# GH5200 Product Change Notifications

Product change notifications (PCN) is a way of informing customers of upcoming changes related to Teltonika products. This includes outward appearance adjustments, hardware improvements, firmware changes, changes to package contents, etc. This page stores information regarding changes to the GH5200 tracking device. Below you will find a list of both upcoming and already implemented changes sorted from newest to oldest (top to bottom).

## 2021.09.23: Battery, GSM, GPS Text changed into graphic logos on the front cover

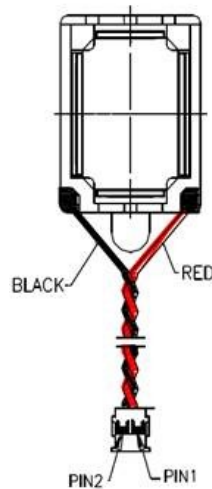
Change type Hardware  
Battery, GSM, GPS Text changed into graphic logos on the front cover  
Old Version:

New Version:

Change reasons Logos is more understandable and can be used for 2G and 4G devices

## 2021.08.25: Changed speaker's connector

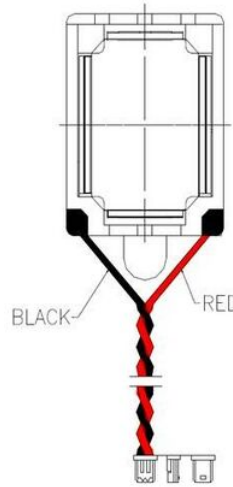
Change type Hardware  
Connector type of the speaker has been changed

Old Version:

New Version:

Change reasons Improved connection stability and vibration resistance.
